Record of Consultation

The purpose of this document is to provide an overview and record of consultation undertaken with Mana Whenua for the development of the Waitomokia Private Plan Change. The record is not extensive and seeks to provide a high-level overview of the Mana Whenua engagement approach undertaken to date.

Project: Waitomokia Plan Change

Precinct Plan 1: Cultural Landscape Values

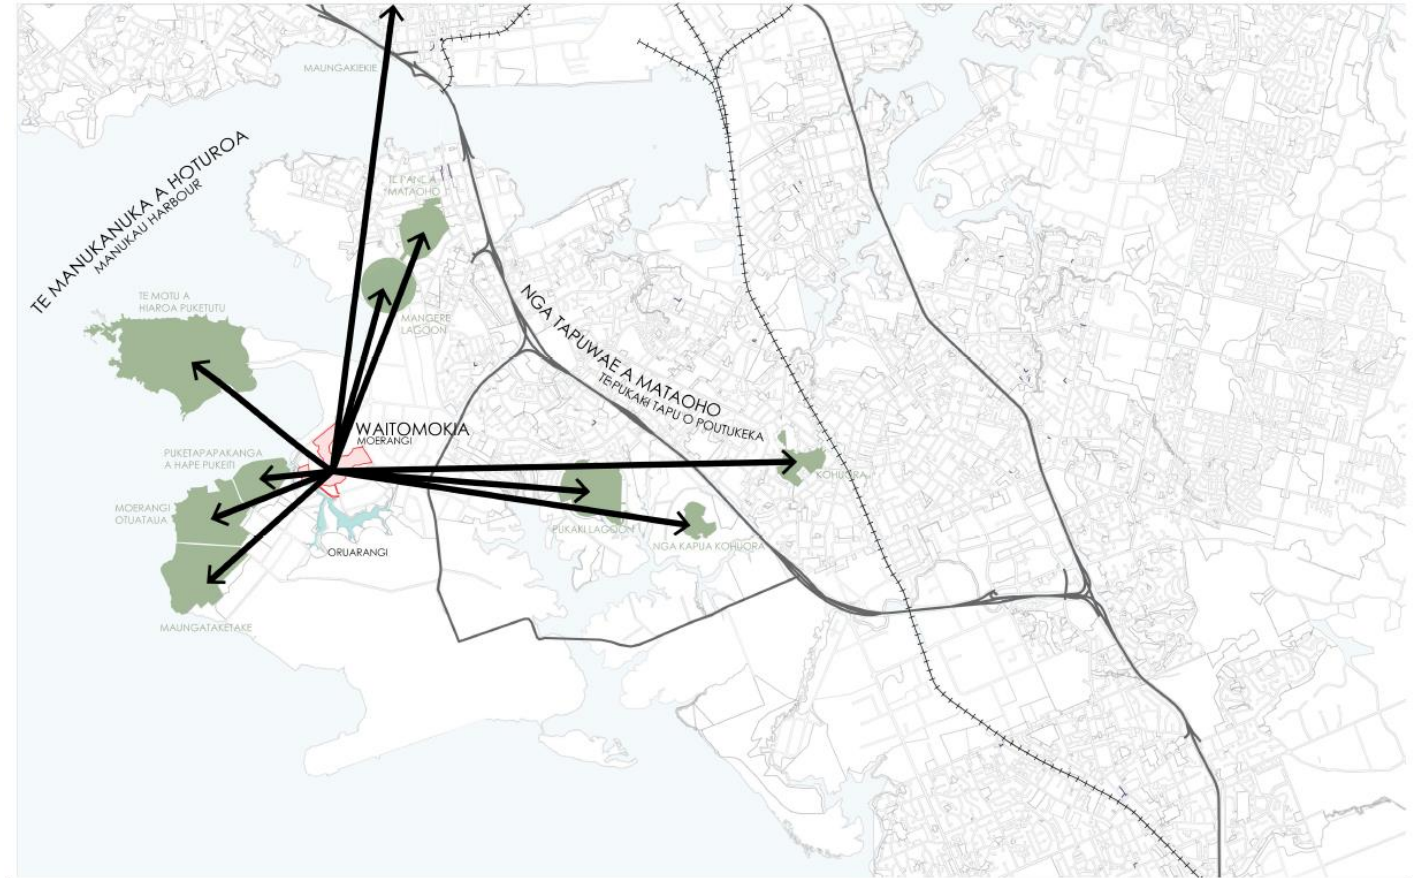
5.	Update Precinct Plan to show a puna in the cultural landscape that is not currently shown.	Precinct Plan 2: Cultural Landscape has been updated to show Puna identified by Te Ahiwaru Waiohua. Refer to blue/purple dot adjacent to Ōruarangi Awa.

Precinct Plan 2: Natural Landscape & Sub-precincts

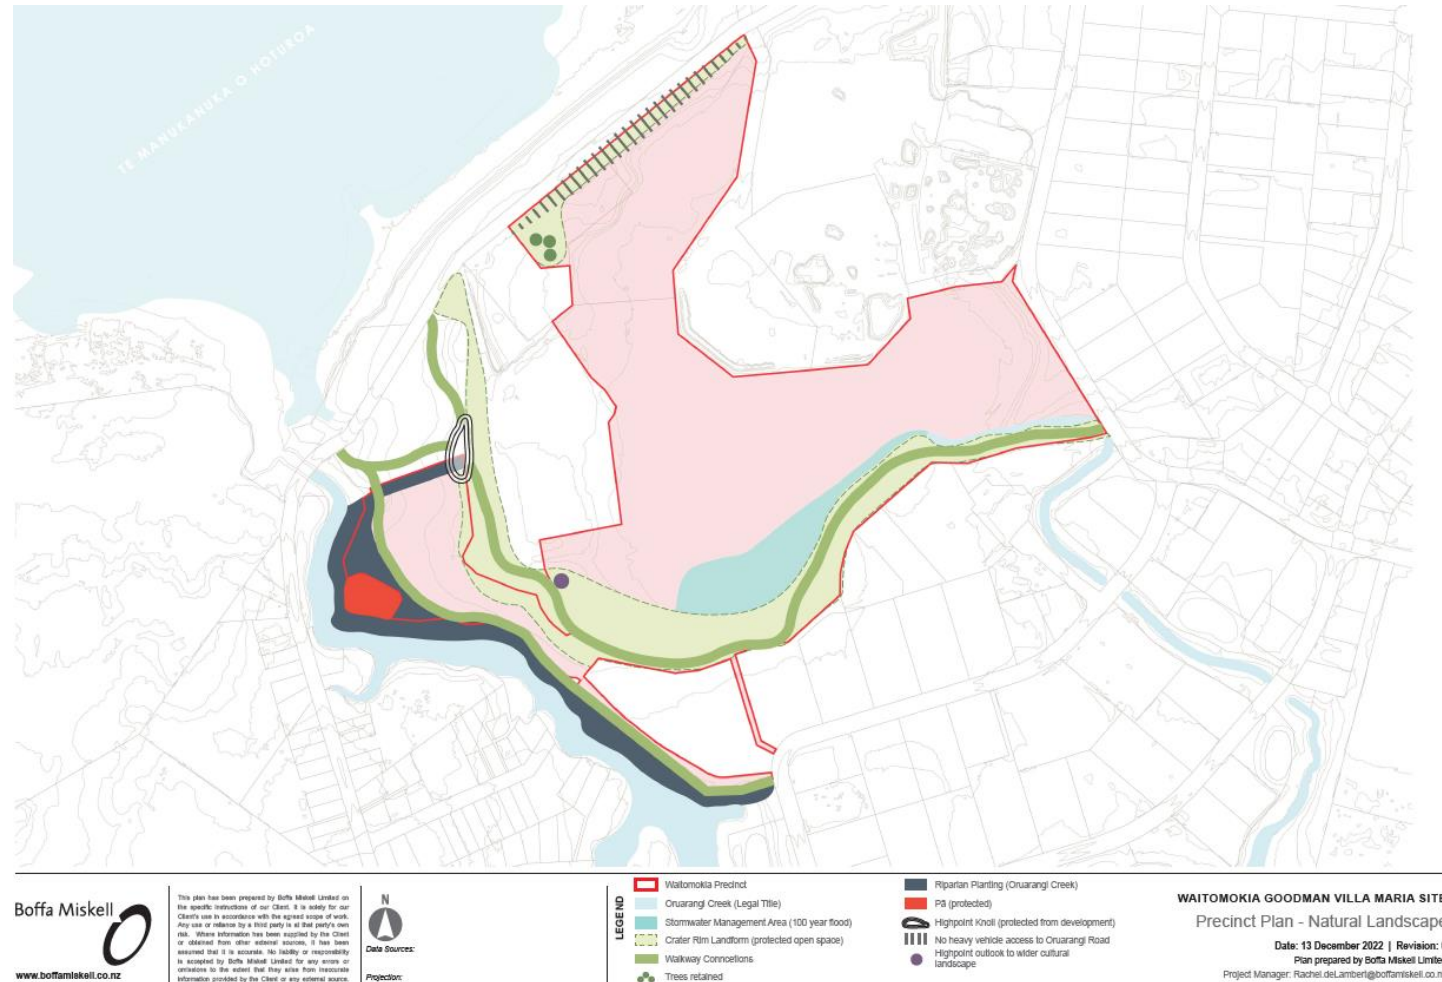
<p>to the Pā site is discouraged and removal of this is supported. However, access to the Pā remains important and should be provided for. Policy 6 should be removed and Precinct Plan 3 should be updated to extend the indicative walkway around the crater rim as opposed to terminating at the Pā site.</p> <ul style="list-style-type: none"> o The MOU must continue to provide Te Ahiwaru with access to the Pā site. <p>- Advised that any discharge to the Oruarangi Awa will need a green outfall design solution.</p>	Goodman
3	<p>Next steps following hui today:</p> <ul style="list-style-type: none"> - Ngati Tamaoho to review plan change in more detail and provide B&A/Goodman with their feedback any proposed changes. - B&A to provide updated version of precinct provisions based on discussions and circulate to Ngati Tamaoho for review. - Goodman will continue with advancing plan change and targeting lodgement in the next 4-6 weeks. - Intention is for Goodman to arrange another pre-lodgement meeting with Council and would welcome Ngati Tamaoho to attend this meeting expressing support for the plan change. 	B&A/Goodman

13.	<p>Policy 6 should be removed and Precinct Plan 3 should be updated to extend the indicative walkway around the crater rim as opposed to terminating at the Pā site.</p>	<p>Deleted policy that relates to access to Pā. Removed indicative walkway, as this already exists. Commitment to provide walkway / access through Waitomokia Plan Change area at the time of development. To be included in the other non-statutory agreements.</p>
